## REQUEST FOR INFORMATION

No. 00043

TITLE: Bath tub drain at Master Bethroom.

PROJECT: CNRI - Cannonsport, LLC

REVISED MASTER BATH TUB PLATFORM  
RFI # 00019

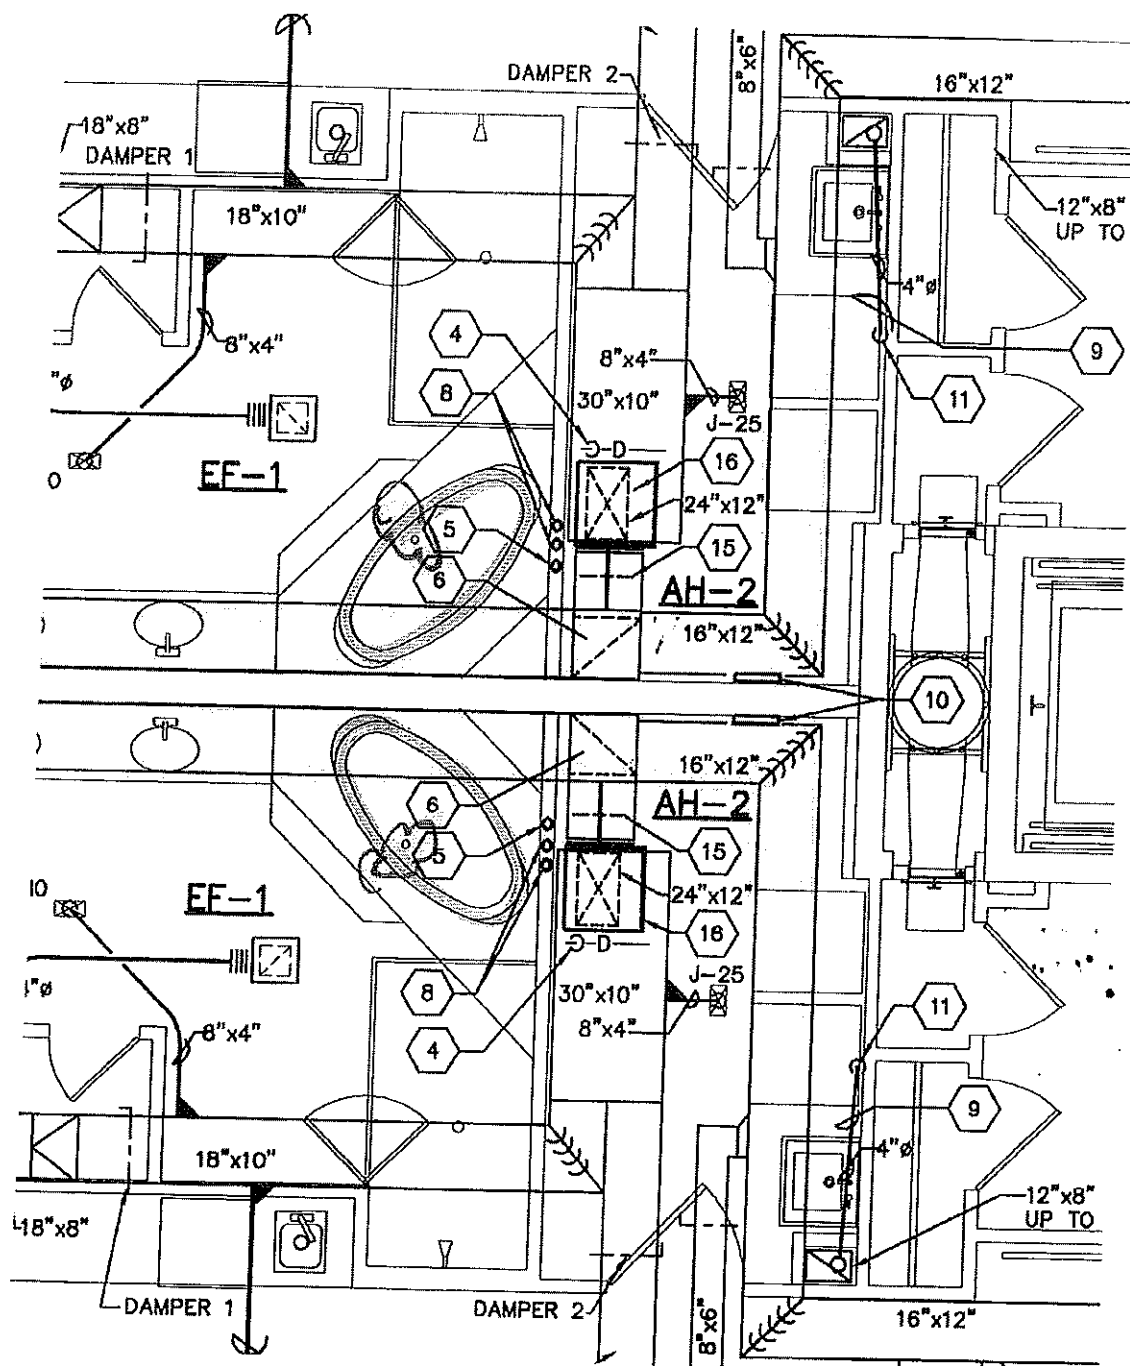
The answer to RFI No. 00019 changed the bath tub due to the reduce space to fit in according to the contract drawings.

The new bath tub has the drain trap located in different area that interfere with the duct work under the slab. Could you please review and give us the instructions how to proceed?

PLEASE ROTATE THE TUB 180° SO THAT THE  
CONTROLS & DRAIN ARE ON THE OPPOSITE END  
OF WHAT IS SHOWN IN RFI 00019.

H-1-2

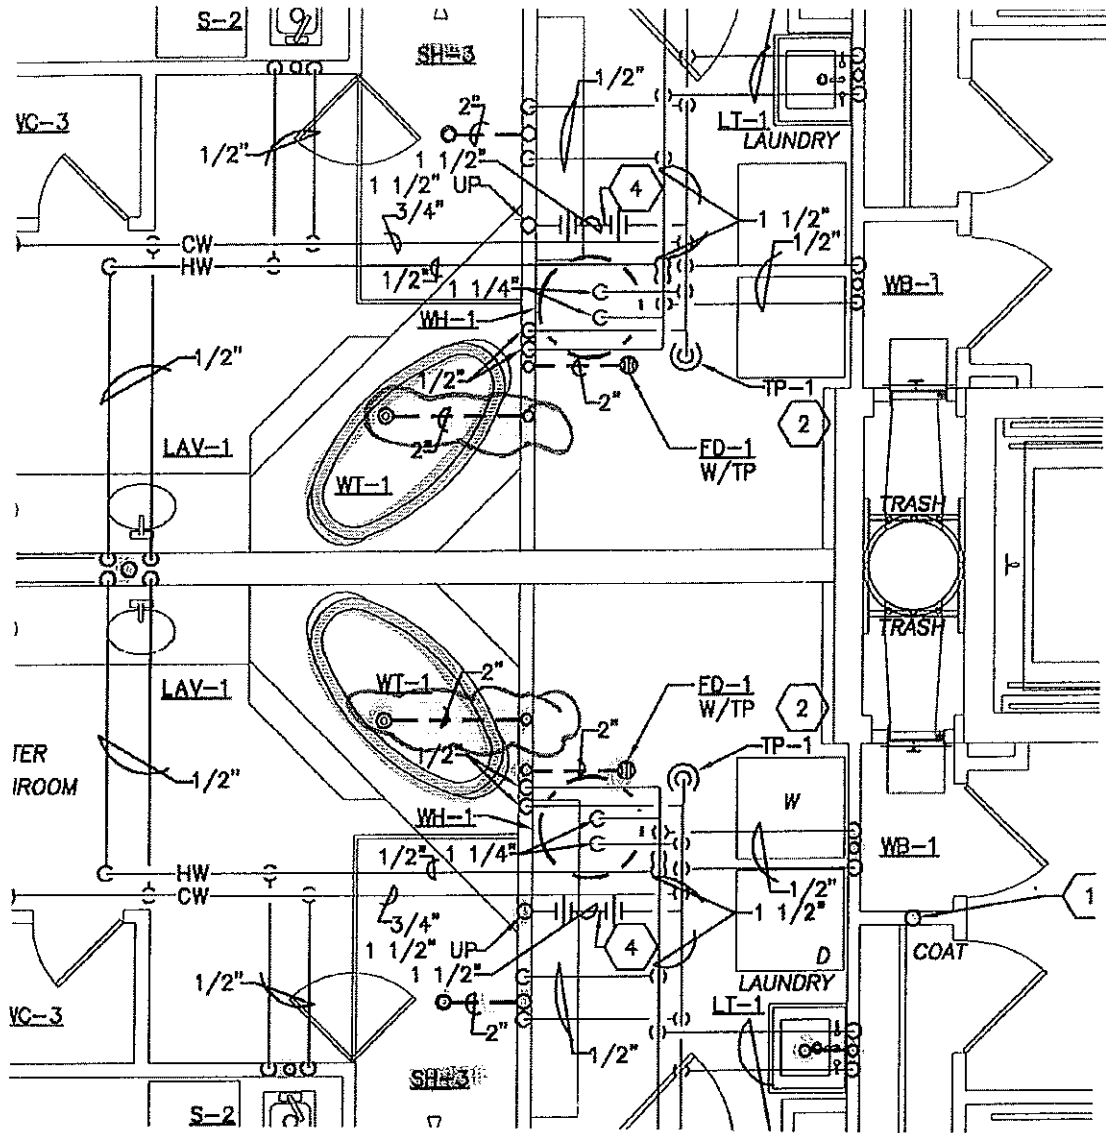
DWGs P1-2 and H1-2
